# UNITED STATES PATENT AND TRADEMARK OFFICE

APPLICATION NO.	FILING DATE	FIRST NAMED INVENTOR	ATTORNEY DOCKET NO.	CONFIRMATION NO.
10/814,149	04/01/2004	Jussi Juva	0837-0168PUS1	7361
2292	7590	07/15/2005	EXAMINER	
BIRCH STEWART KOLASCH & BIRCH PO BOX 747 FALLS CHURCH, VA 22040-0747				NGUYEN, TAM M
ART UNIT		PAPER NUMBER		
3764				DATE MAILED: 07/15/2005

<b>Office Action Summary</b>	<b>Application No.</b>	<b>Applicant(s)</b>	
	10/814,149	JUVA, JUSSI	
	<b>Examiner</b>	<b>Art Unit</b>	
	Tam Nguyen	3764

FIG. 2B

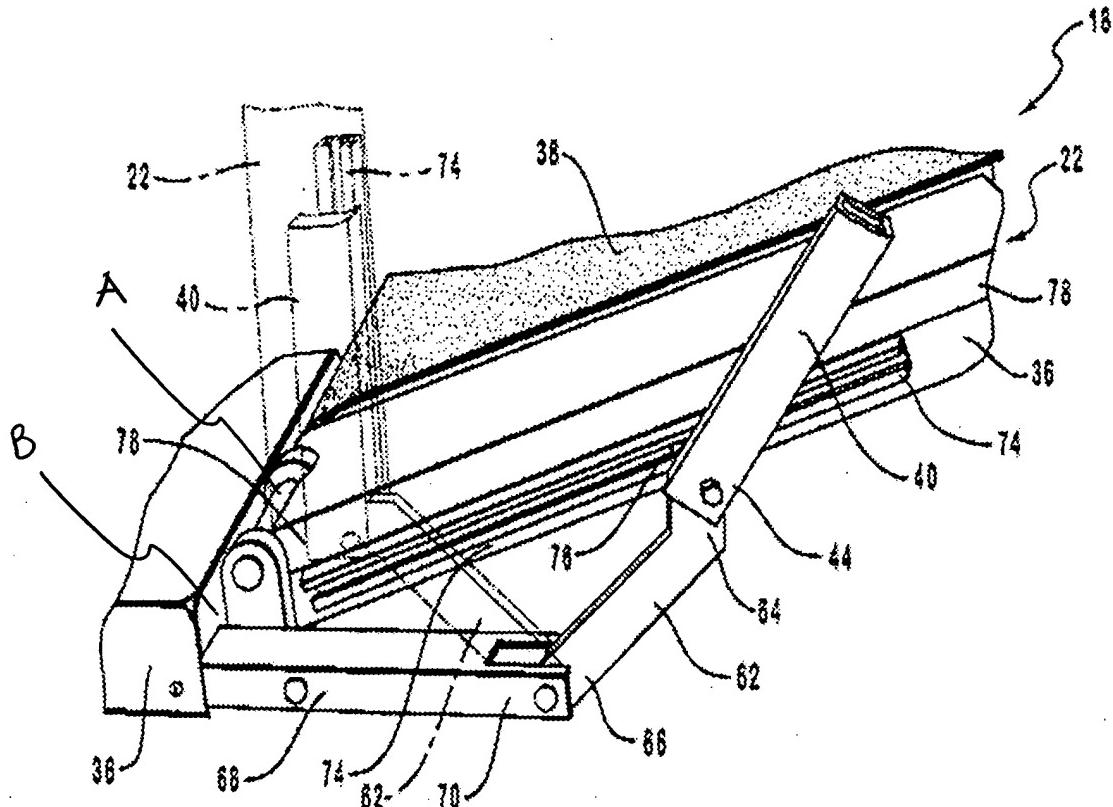
4. As to claims 1, 2 and 6, Dalebout discloses a treadmill comprising a frame (20,22), an endless belt (34) arranged around two rolls on the frame, first means (98) for turning the belt, second means (motor at feet 92) for adjusting the tilt of the belt and a hand support structure (46) comprising a support part (40) on both sides of the frame (see Col. 8, lines 31-42 & Figs. 1-5). The treadmill also includes an entity comprising said support parts (40) and low supports (62,68) wherein the entity is turnably pivoted to the frame by means of a transverse shaft (A) as substantially claimed (see Fig. 2B below). Dalebout also discloses that the low supports are arranged to extend past the back end of the frame (as shown by reference B in Fig. 2 B below).
